**Government of India
Ministry of Railways
Research, Designs & Standards Organisation
Manak Nagar, Lucknow - 226 011**

No.EL/3.2.1

MODIFICATION SHEET NO. WAM4/185

CONVERSION OF TRANSFORMER TYPE BOT- 3460 TO TYPE HETT-3900

SKEL 4325

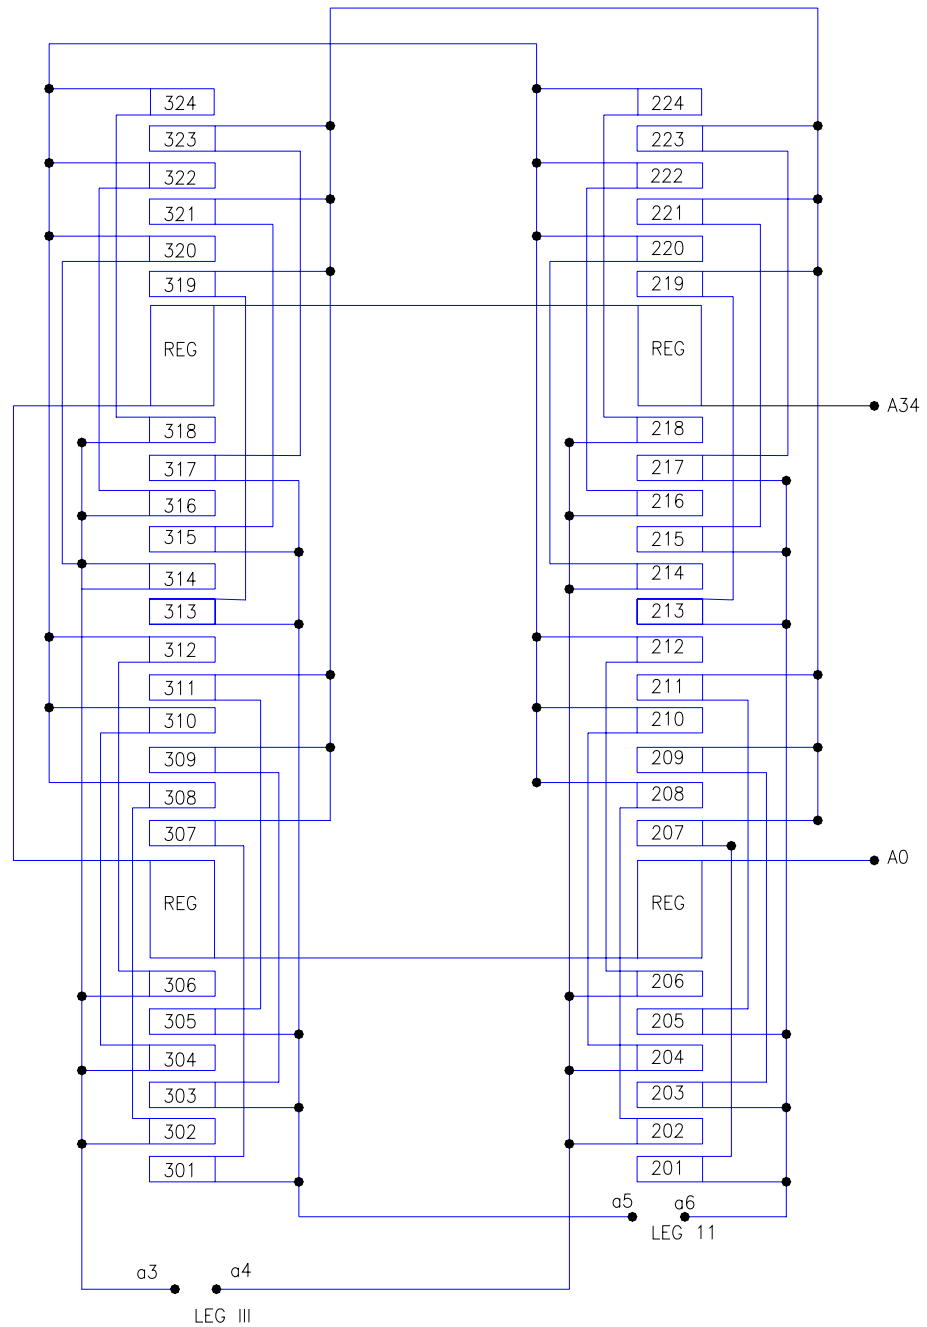
- i) Untank the core coil assembly of the transformer type BOT-3460. Remove the transformer cover after unscrewing the 6 core supporting bolts and disconnect bushing terminals.
- ii) Identify the 24 coil discs each of both the traction windings a3-a4 and a5-a6 indicated in RDSO drawing No. SK. EL. 4325 and Schematic Drawing No.4327 enclosed. Coil series 200-300 indicated in the drawing item limb II/III respectively.
- iii) Disconnect the coil coupling leads of the two series connected coils on limb II and III of the two traction windings as shown in schemative drawing No. SK. EL. 4327.
- iii) Braze suitable lugs on the dis-connected coil disc leads and insulate the junction of the coil disc lead and lug with half layer of cotton tape. Due care should be taken to avoid heat conduction and breakage of strands while brazing.

SKEL 4326

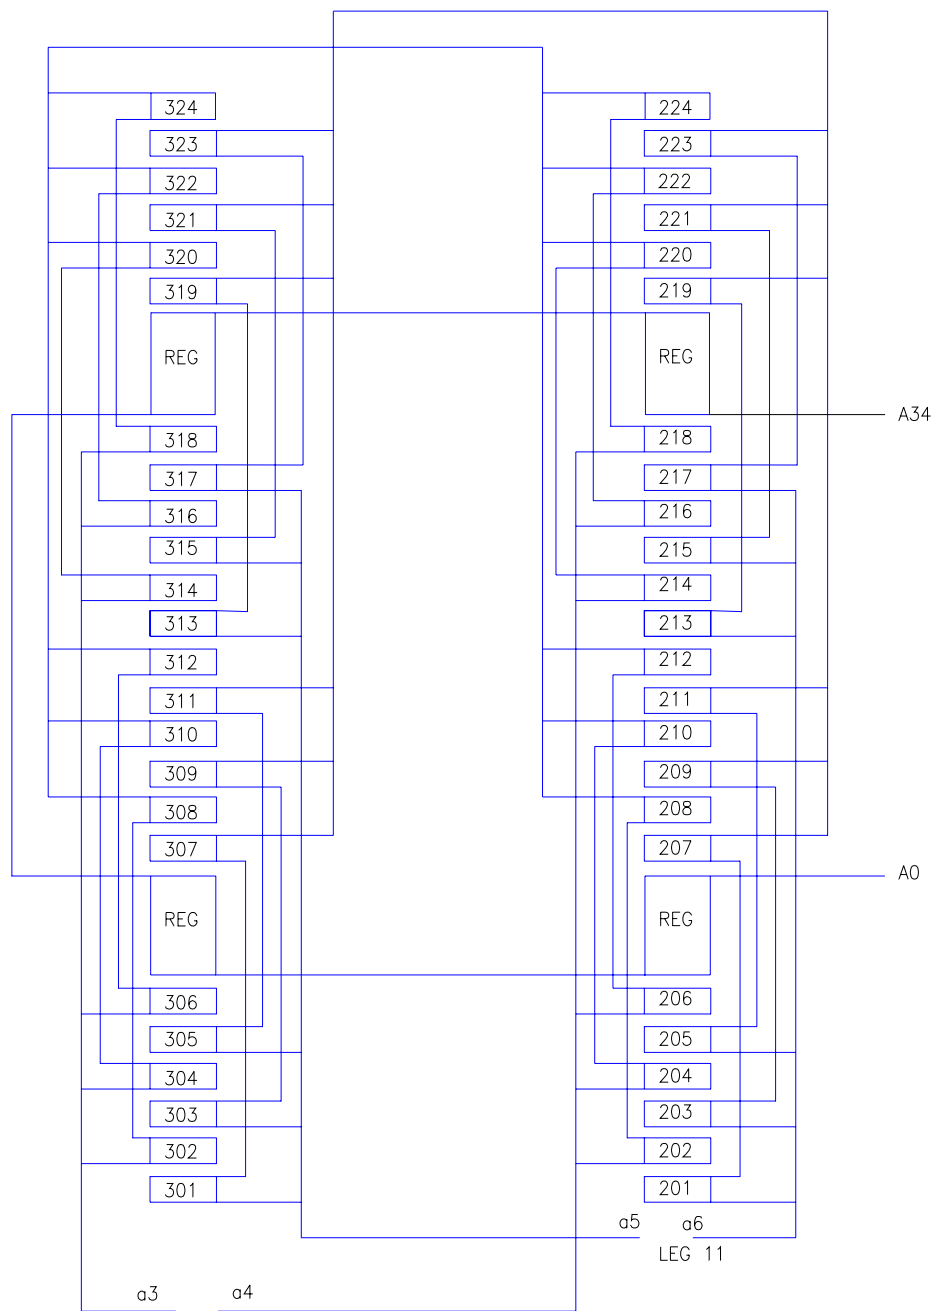
- iv) Replace the existing 8 nos. of bus bars of size of the 5x50 mm of traction windings on which coil disc leads are connected with bus bar of size 8x50 mm having in 'L' clamp arrangement similar to HETT 3900 KVA type for the required inter- connectinos as indicated in RDSO drg. NO. SK. EL.-4326 enclosed. It is to be noted that in the process the supporting arrangement and length of a3 bus bar get changed similar to HETT type.

- vi) Reconnect the coil discs in IS-12P combination on limb II for each traction winding. Similarly, the other coils disc on limb III to be connectd. The coil discs lying on limb II and limb III of each traction winding should further be connected in series as shown in RDSO drg. No. SK. EL. 4326 and Schematic Drawing No. SK. EL.-4328 enclosed.
